NOTICE OF CHANGE TO A PROPOSAL AND NOTICE OF PUBLIC MEETINGS

The Renewable Energy Approval (REA) Application was submitted to the MOE on February 15, 2013. Since then, modifications to the Project have been proposed; the proposed modifications are categorized as follows (**see Figure 1**):

Figure 1: Jericho Wind Energy Centre Project Layout with Proposed Modifications

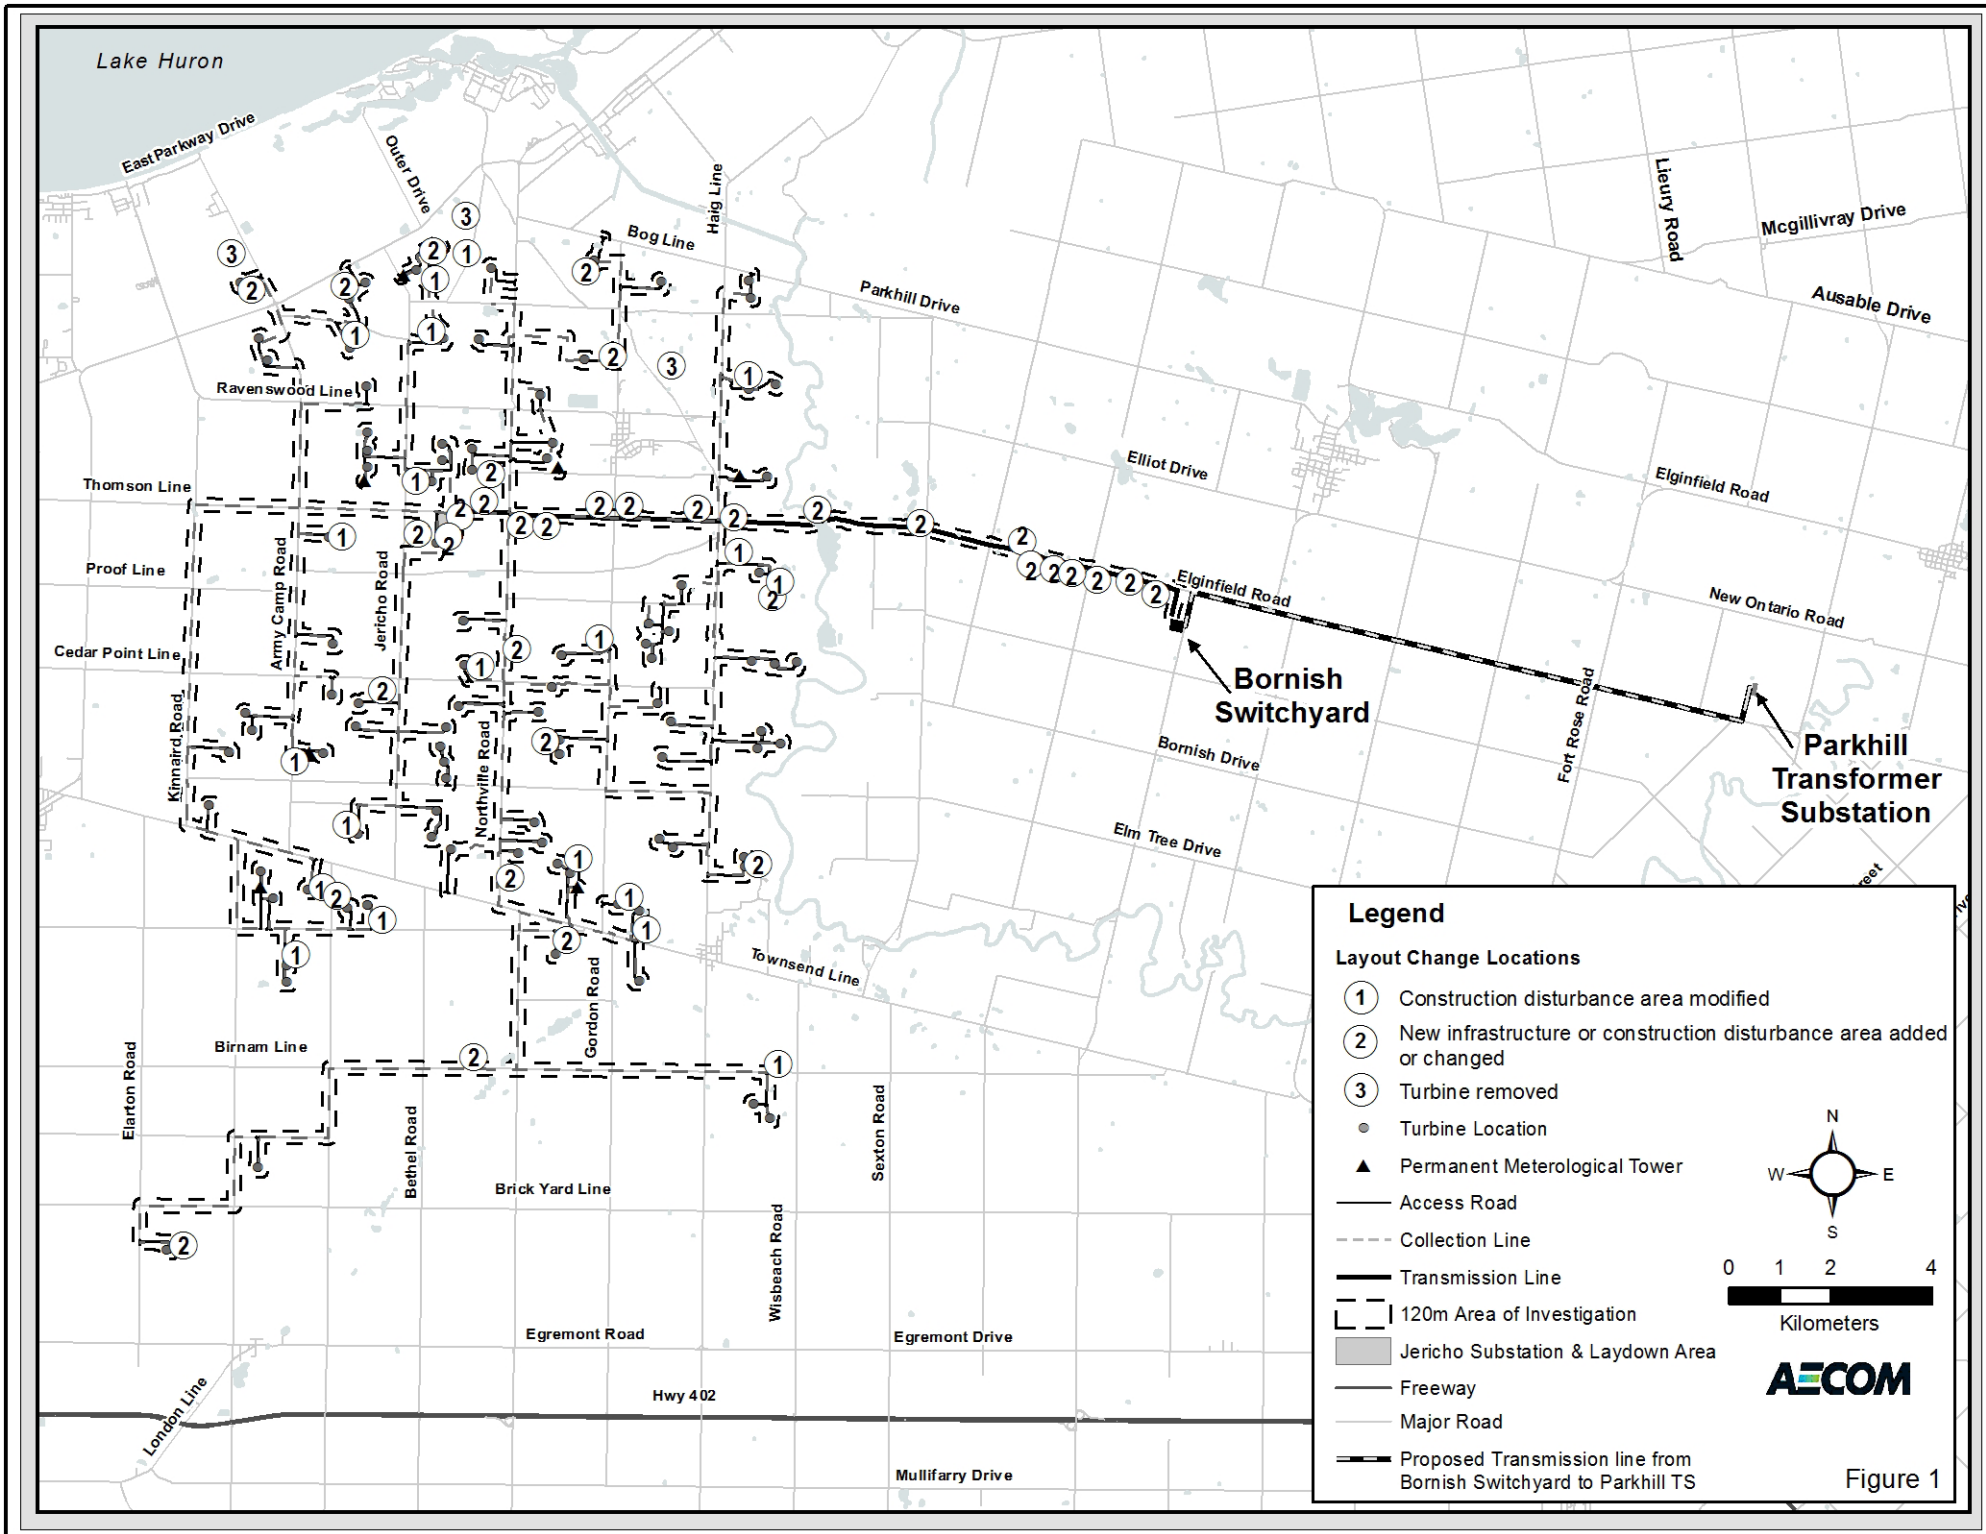
1. Construction disturbance areas modified to reduce or eliminate impacts to archaeological resources
2. New infrastructure or construction disturbance areas added or changed to improve project design
3. Turbines removed
